ADDENDUM

7 February 1992

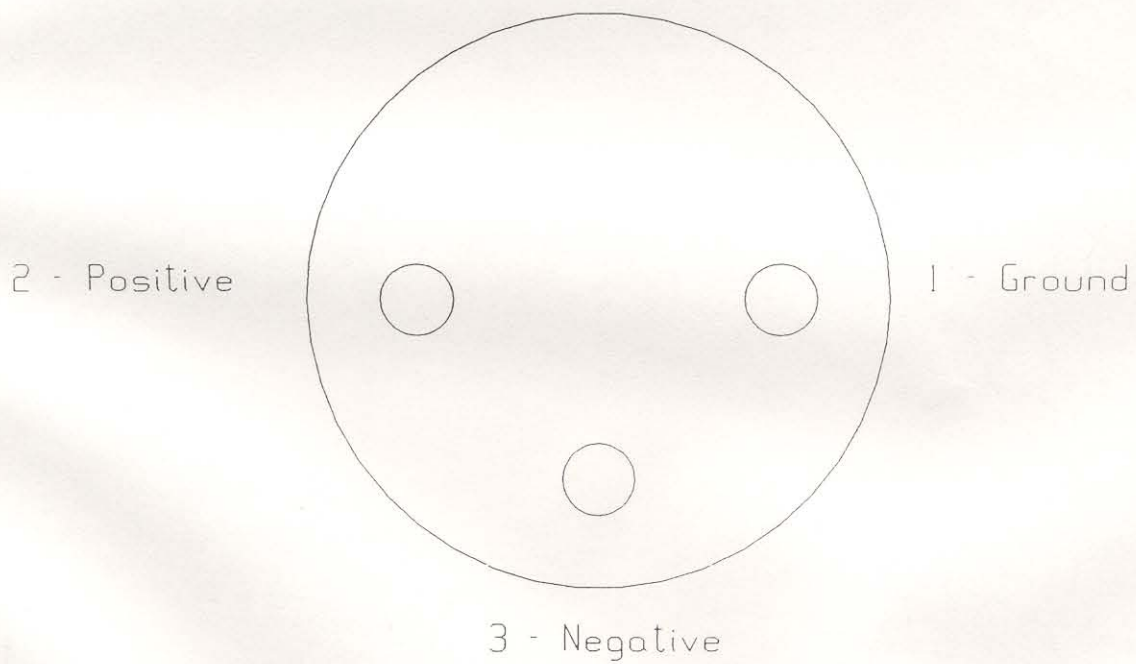
It has been noted that the connections to the balanced input of the 605 have been omitted. The connections are as follows:
